DESIGN ADVISORY BOARD Tuesday February 9, 2021 3:00 PM REMOTE MEETING

1. **21-0641CA; 2-14 King Street (DW-PT, Ward 3C) Lake Champlain Transportation Company**

MEMORANDUM

To: The Design Advisory Board
From: Ryan Morrison, Associate Planner
RE: ZP21-0641CA; 2-14 King Street
Date: February 9, 2021

1 PROPOSED EAST ELEVATION
SD-2 3/16" = 1'-0"

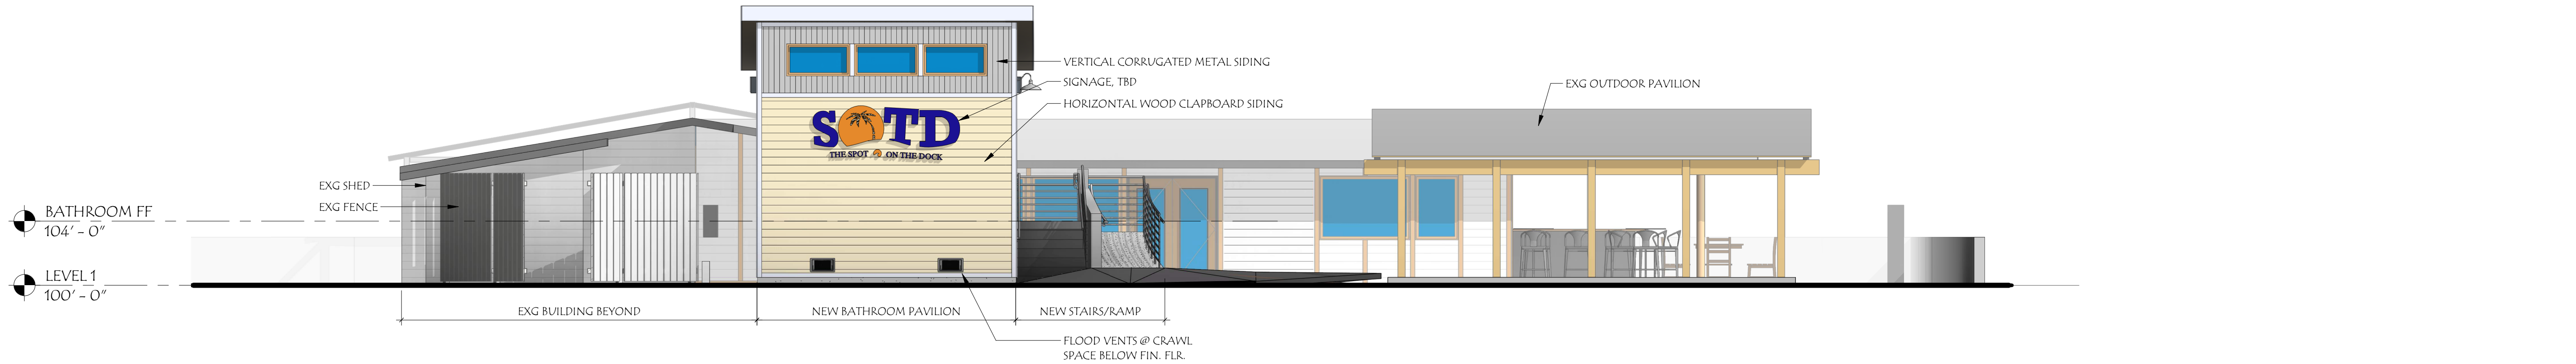
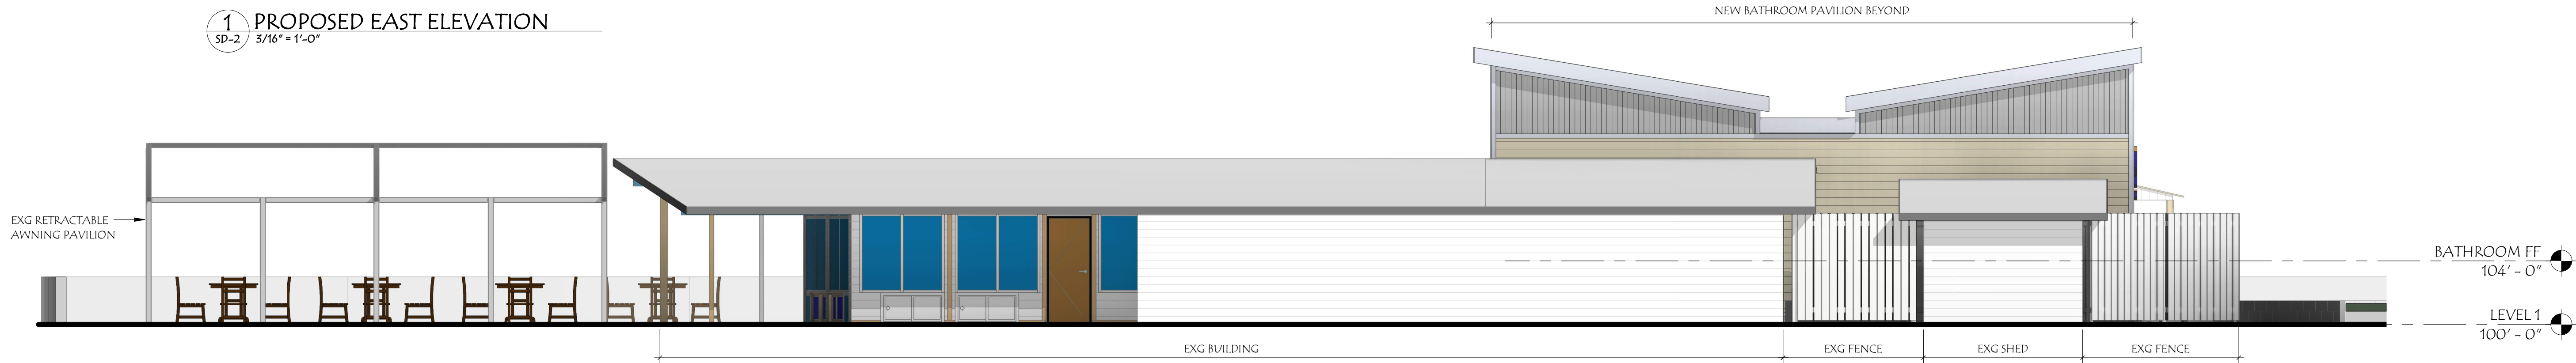
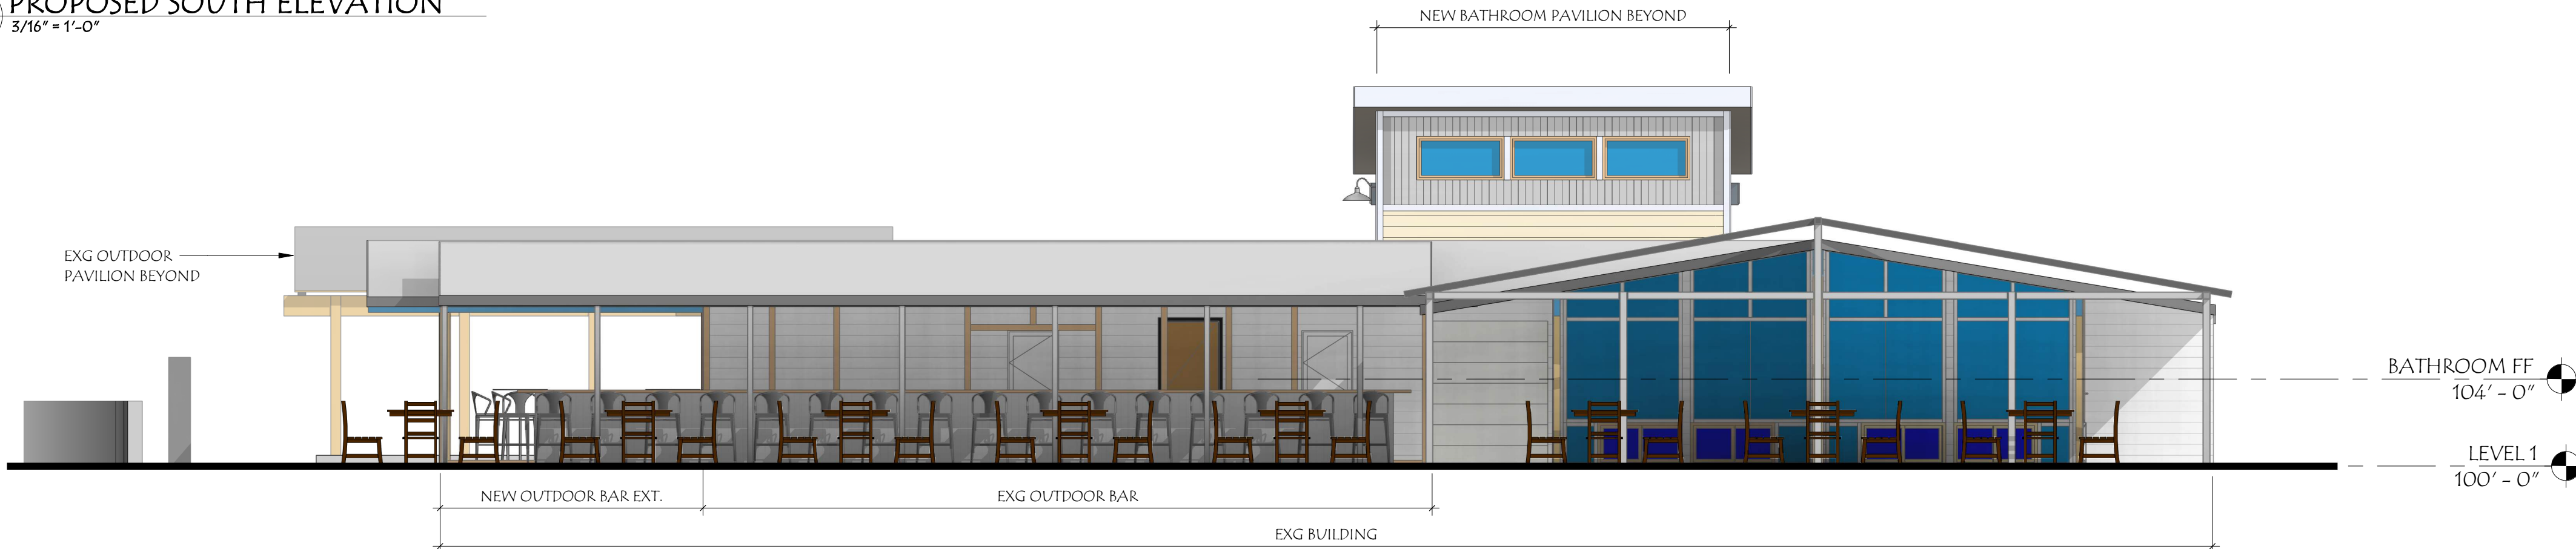
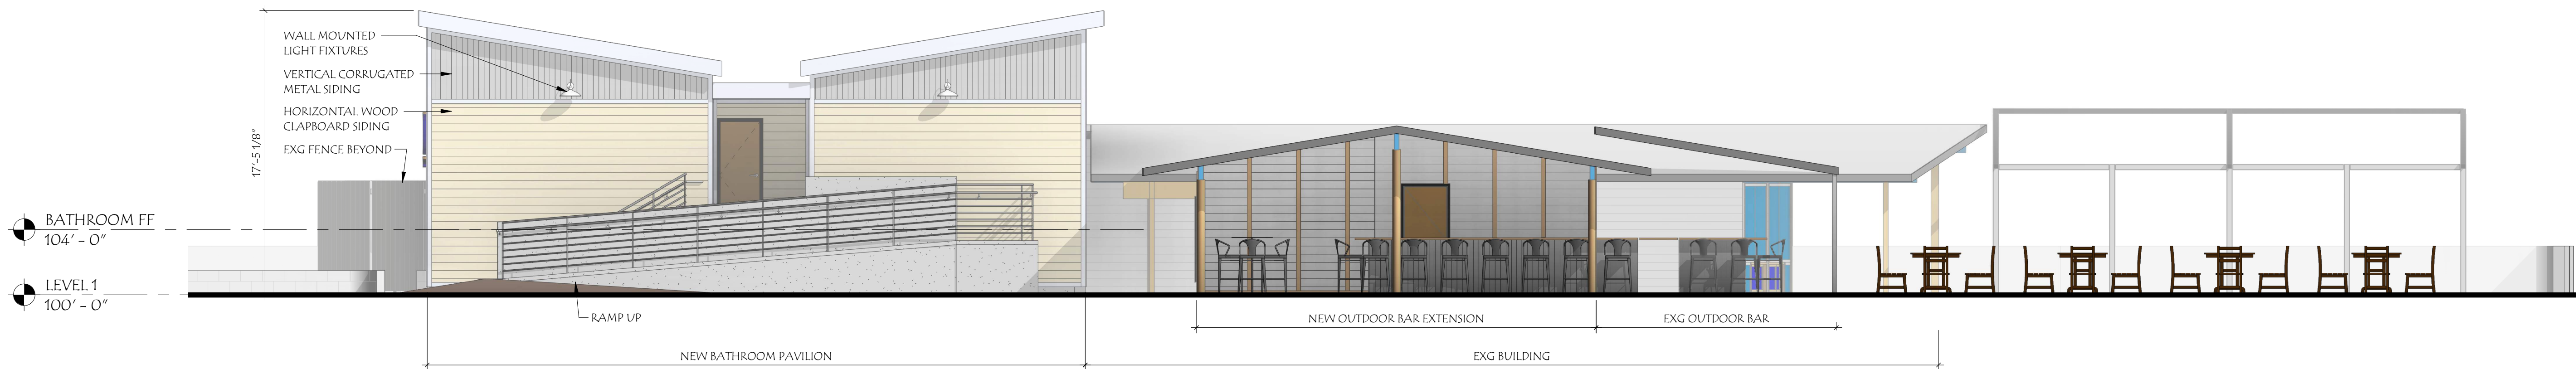
The elevation plans show two wall-mounted light fixtures on the north wall of the new restroom building that will provide illumination for pedestrian access. Recessed light fixtures will be installed into the ceiling for the outdoor bar area.

show the new restroom building at a height taller than the existing restaurant building. However, the front façade (east), will be broken up with two different siding types, a new sign for Spot on the Dock, and windows, all in an effort to provide relief from what could be a monotonous façade. Given that this development is located deep within a highly developed property, impacts to nearby public streets and other development will be negligible.

The new restroom structure will have three windows on both ends (west and east façades), and a covered pedestrian entrance on the north side. Since this is a restroom, having many openings is undesirable. However, in an effort to create a more attractive front wall (east façade), the applicant proposes the windows, a new sign, and two different types of siding. Aside from the three windows on both ends and the pedestrian access, no other openings are proposed.

The proposal calls for wood clapboard siding on the majority of the restroom building, with vertical corrugated metal siding on the higher portions. The access ramp will be concrete. Specifics on the windows have not been provided, however, since this is a new construction, any commercial grade windows will more than likely be acceptable.
